Technical Service Information

FORD A4LD 3-4 SHIFT SOLENOID CHANGE

Figure 1

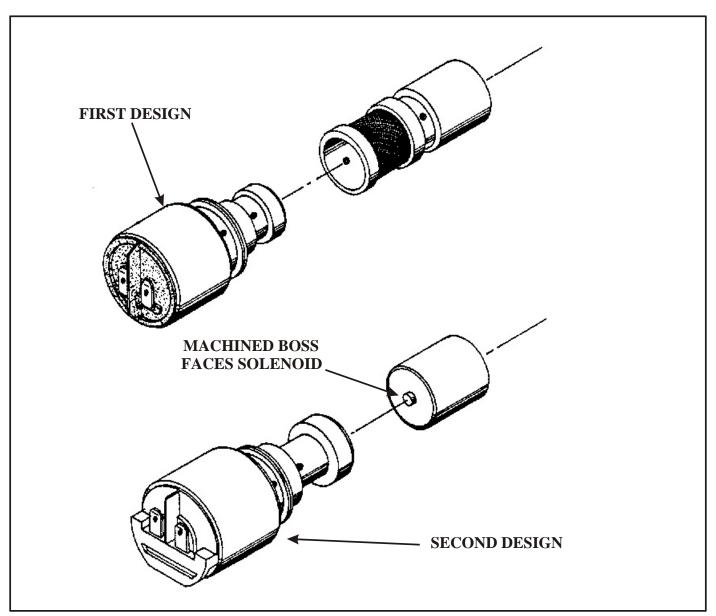
There has been a design change on the 3-4 shift solenoid on the Ford A4LD, and the new design level solenoid is still available under the old OEM number E8TZ-7M107-A. The 1st design 3-4 shift solenoid had a sleeve that incorporated a screen for the solenoid as shown in Figure 1. The 2nd design eliminates the screen, has dimensional changes on the solenoid itself, and includes a new plug with a boss machined on one end. The plug must be installed with the machined boss facing the solenoid as shown in Figure 1. The 2nd design 3-4 shift solenoid WILL retro-fit back to all previous models, if it is required.
